**NEW YORK STATE THRUWAY AUTHORITY
DEPARTMENT OF ENGINEERING**

**AMENDMENT NO. 2
TO**

**CONTRACT TAN 26-14
D215082
PAVEMENT REHABILITATION AND MISCELLANEOUS
WORK ON I-190, NIAGARA THRUWAY
FROM MP N0.7 TO MP N4.2
IN THE BUFFALO DIVISION
OF THE NEW YORK STATE THRUWAY
IN ERIE COUNTY**

**IN THE LETTING OF
FEBRUARY 25, 2026**

TITLE OF PROJECT I-190 HIGHWAY REHABILITATION	CONTRACT NUMBER: TAN 26-14
LOCATION OF PROJECT I-190 NIAGARA THRUWAY MP 900.7 TO MP 904.2	DATE: FEB. 2026
TITLE OF DRAWING WZTC SOUTHBOUND SECTION 2/ PHASE 1/ STAGE 1	DRAWING NUMBER: TCP-30

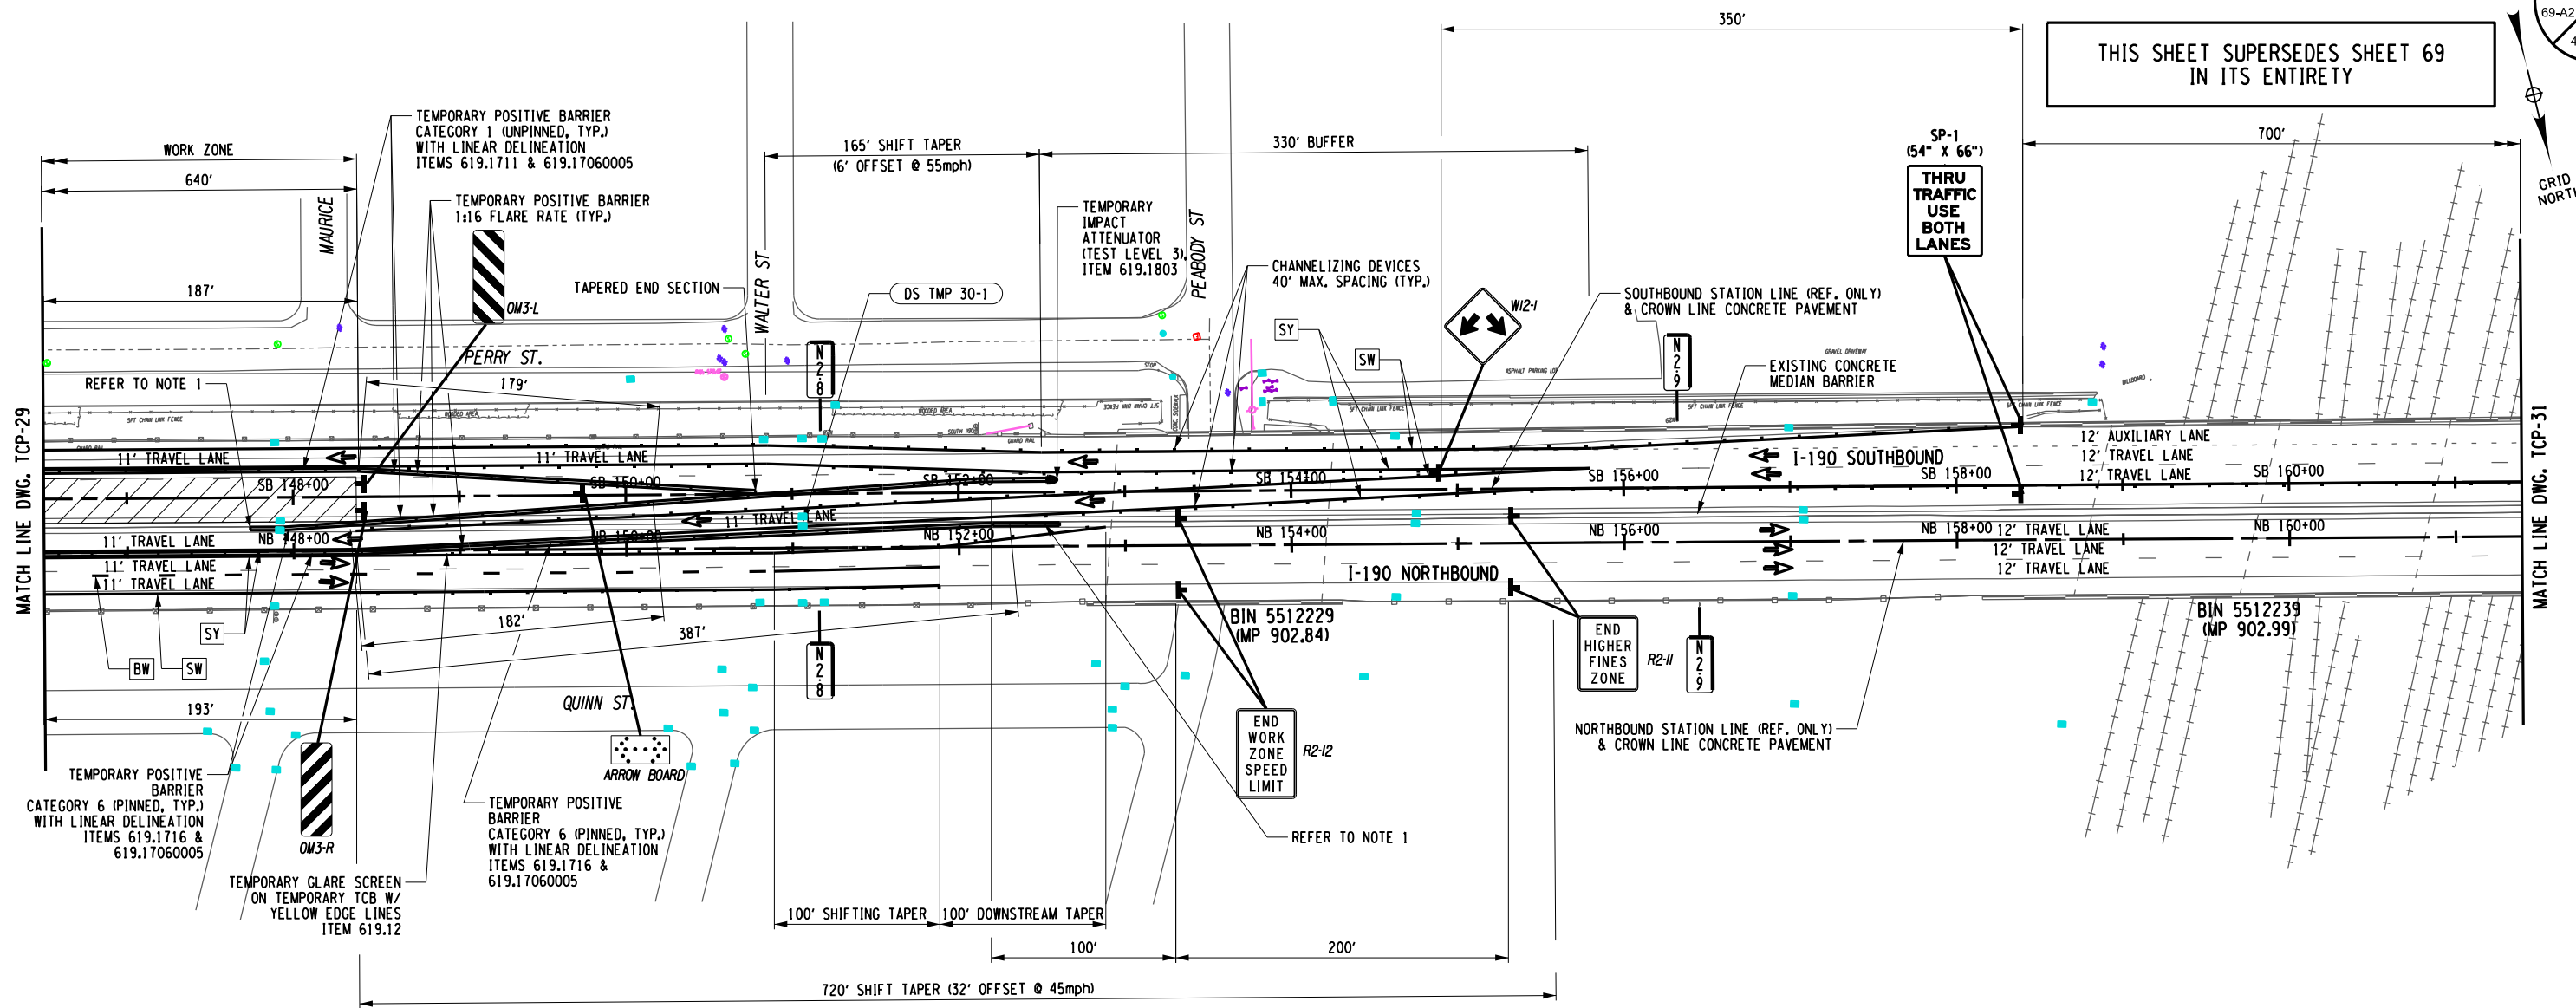
2. **DELETE** Drawing Number TCP-30, Sheet 69 of 421, and **SUBSTITUTE** with the attached Drawing Number TCP-30, Sheet 69-A2 of 421. “SP-1” signs were changed to fit field conditions, and the size of the SP-1 sign was added to the sheet.

TITLE OF PROJECT I-190 HIGHWAY REHABILITATION	CONTRACT NUMBER: TAN 26-14
LOCATION OF PROJECT I-190 NIAGARA THRUWAY MP 900.7 TO MP 904.2	DATE: FEB. 2026
TITLE OF DRAWING WZTC SOUTHBOUND SECTION 2/ PHASE 1/ STAGE 1	DRAWING NUMBER: TCP-31

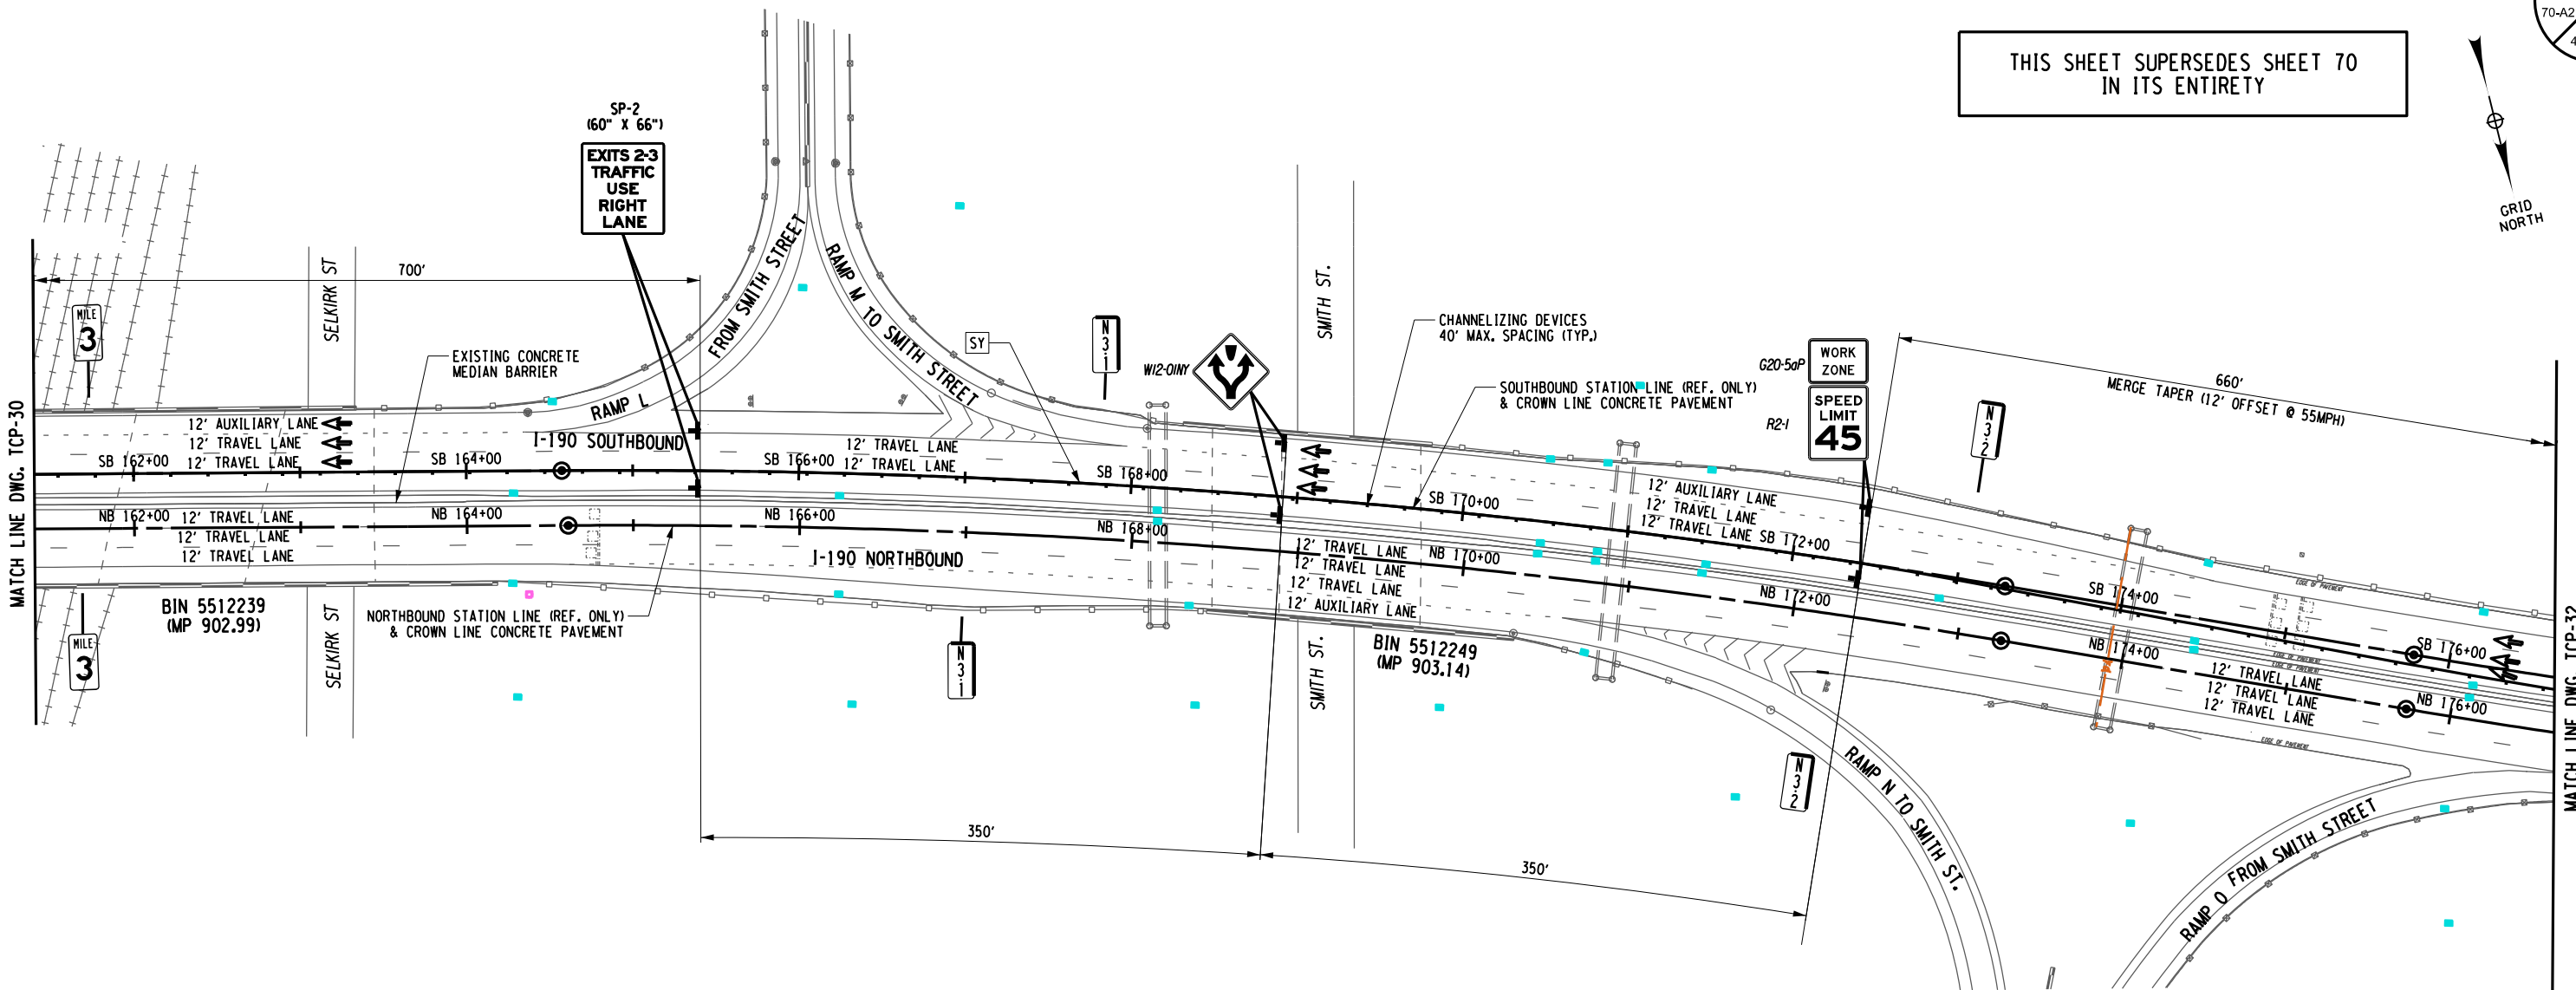
3. **DELETE** Drawing Number TCP-31, Sheet 70 of 421, and **SUBSTITUTE** with the attached Drawing Number TCP-31, Sheet 70-A2 of 421. “SP-2” signs were changed to fit field conditions, and the size of the SP-2 sign was added to the sheet.

TITLE OF PROJECT I-190 HIGHWAY REHABILITATION	CONTRACT NUMBER: TAN 26-14
LOCATION OF PROJECT I-190 NIAGARA THRUWAY MP 900.7 TO MP 904.2	DATE: FEB. 2026
TITLE OF DRAWING WZTC SOUTHBOUND SECTION 2/ PHASE 1/ STAGE 2	DRAWING NUMBER: TCP-40

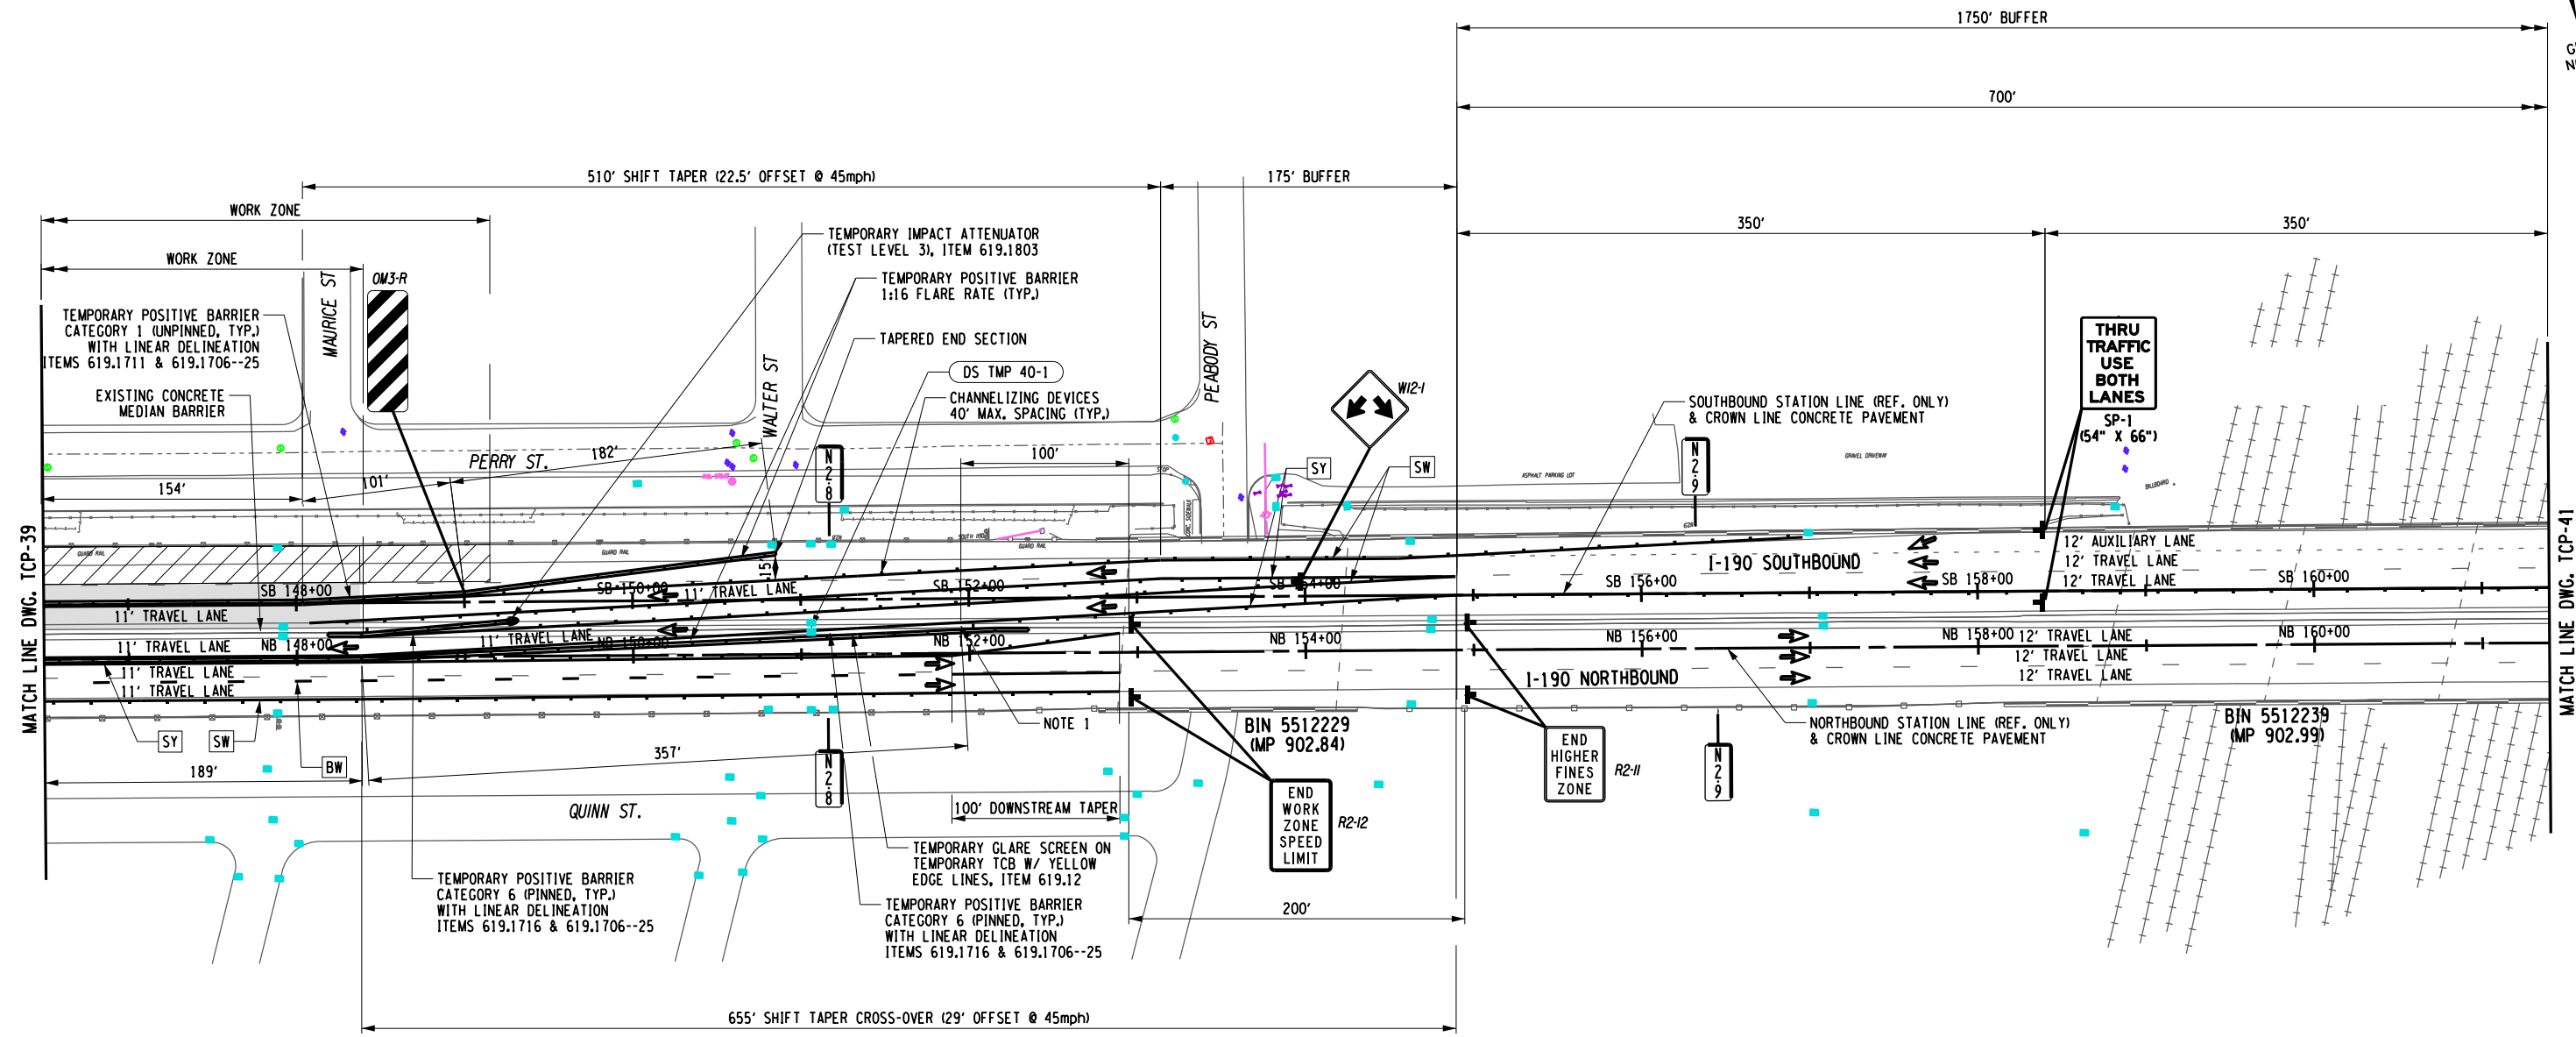
4. **DELETE** Drawing Number TCP-40, Sheet 79 of 421, and **SUBSTITUTE** with the attached Drawing Number TCP-40, Sheet 79-A2 of 421. “SP-1” signs were changed to fit field conditions, and the size of SP-1 sign was added to the sheet.

TITLE OF PROJECT I-190 HIGHWAY REHABILITATION	CONTRACT NUMBER: TAN 26-14
LOCATION OF PROJECT I-190 NIAGARA THRUWAY MP 900.7 TO MP 904.2	DATE: FEB. 2026
TITLE OF DRAWING WZTC SOUTHBOUND SECTION 2/ PHASE 1/ STAGE 2	DRAWING NUMBER: TCP-41

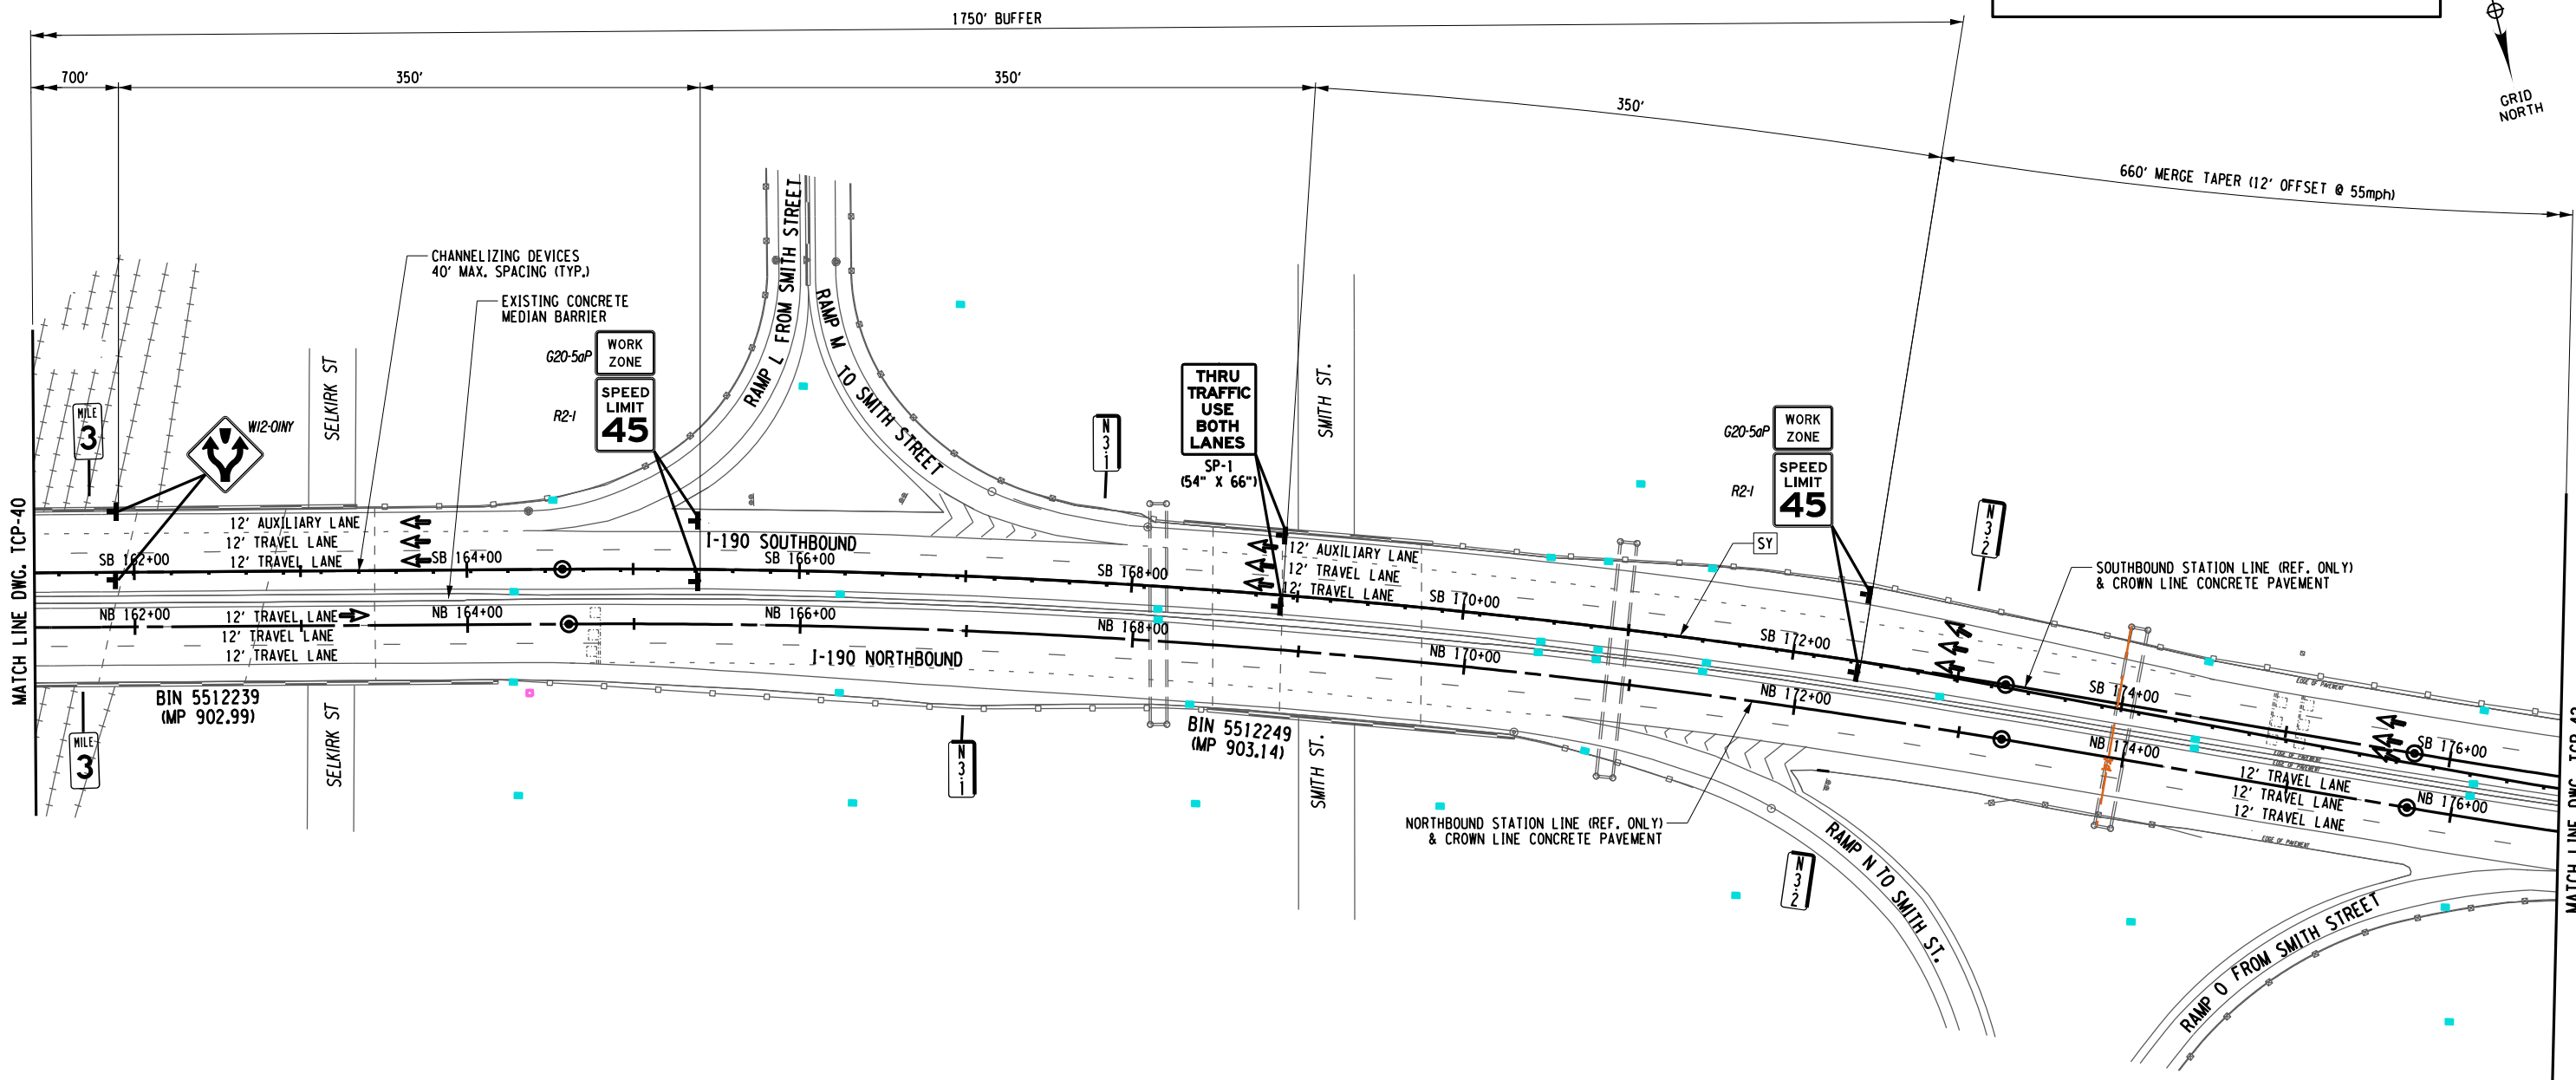
5. **DELETE** Drawing Number TCP-41, Sheet 80 of 421, and **SUBSTITUTE** with the attached Drawing Number TCP-41, Sheet 80-A2 of 421. “SP-1” signs were changed to fit field conditions, and the size of SP-1 sign was added to the sheet.
